Amendment of the Bay-Delta Water Quality Control Plan's Compliance and Baseline Monitoring Program

Presented to the State Water Resources Control Board
By Stephen Ford (DWR) and Erwin Van Nieuwenhuysse (Reclamation)
October 27, 2004

Figure 2: Conceptual Design of Water Quality Compliance and Baseline Monitoring Program

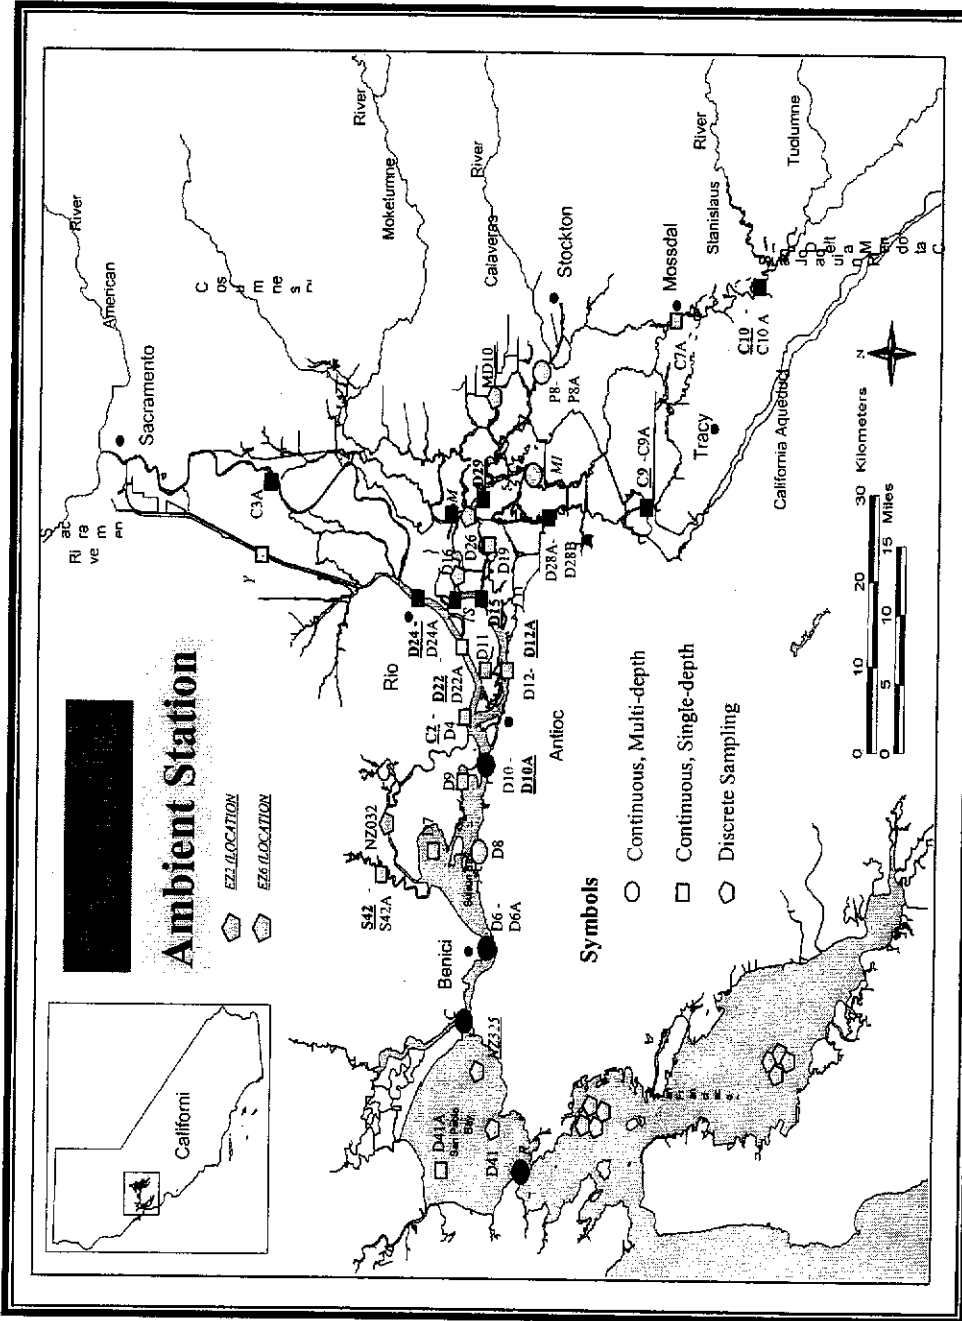
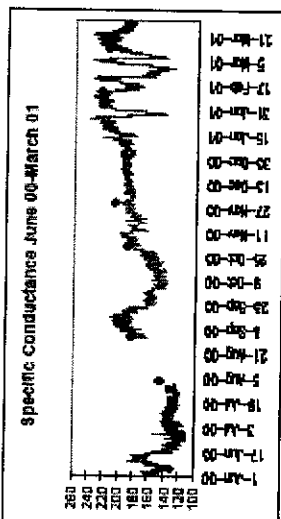
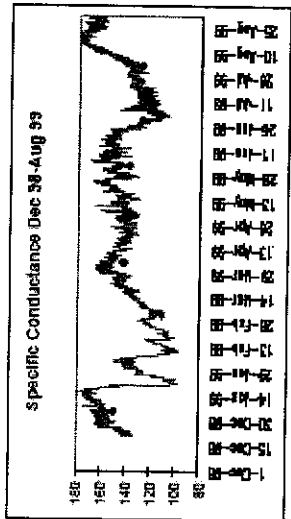
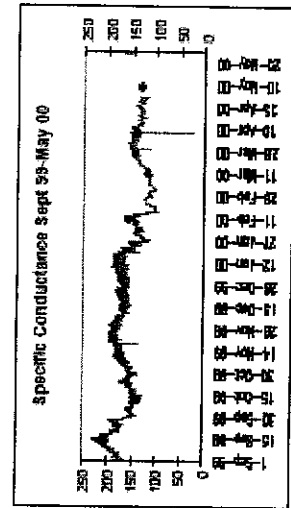
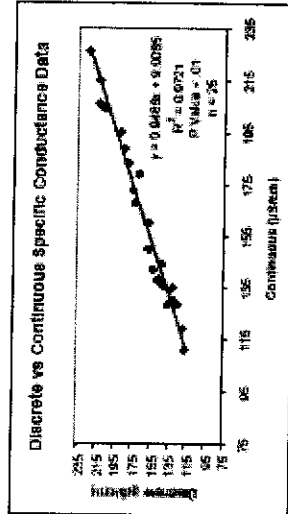
- Improve the scientific basis for the program and the usefulness of the resulting data by
 - Enhancing comprehensive monitoring at important ambient and flux stations (Figure 2 of this document)
 - Enhancing continuous monitoring
 - Increasing shallow water monitoring
 - Reducing spring-neap tidal biases

Figure 4: Proposed Revision of Figure 2 of the 1995 Bay-Delta Water Quality Control Plan

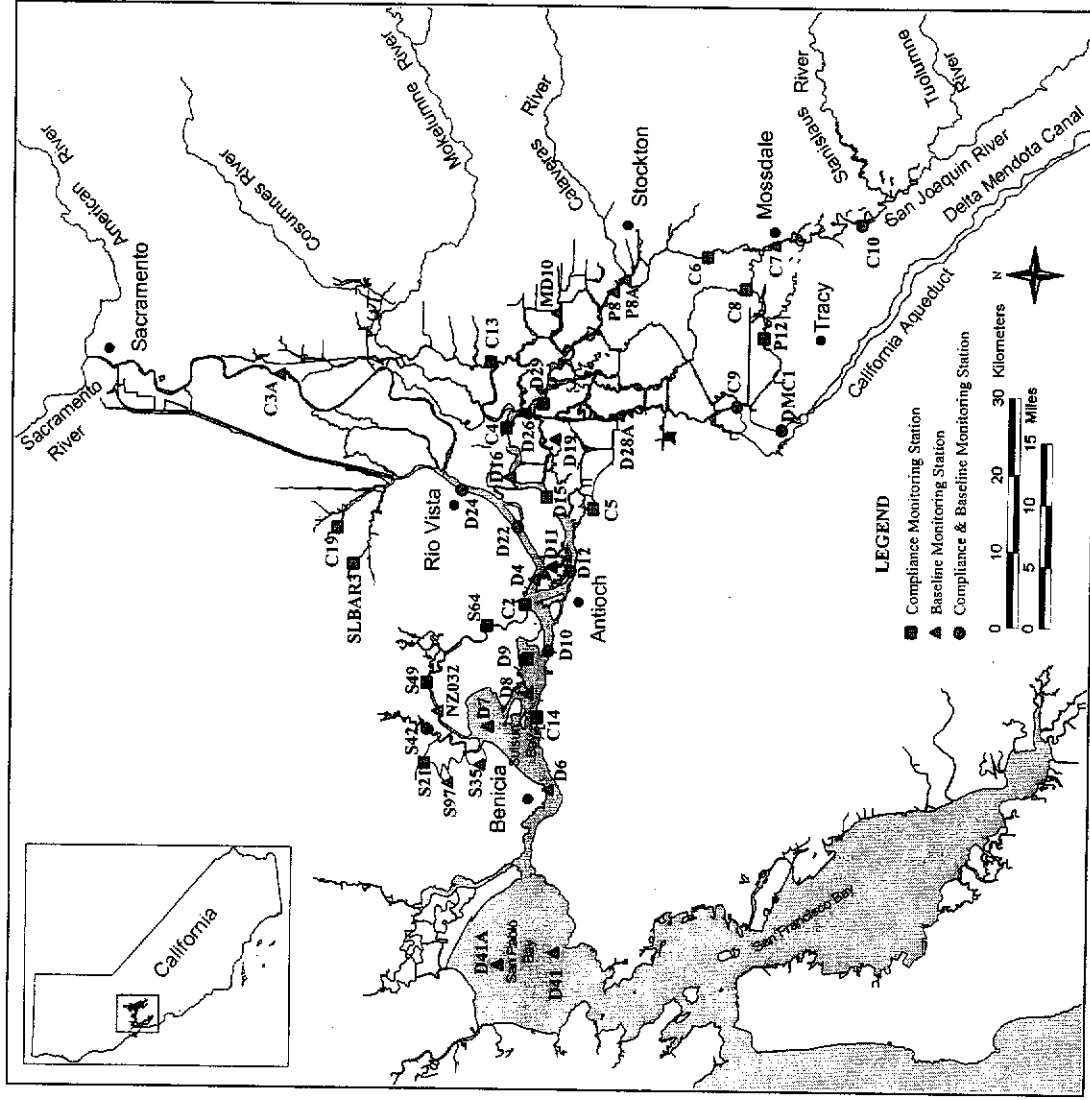
The amendment of Figure 2 of the Plan would reflect the previously proposed changes to the monitoring plan. Figure 4 of this document shows the proposed revision of the Plan's Figure 2.
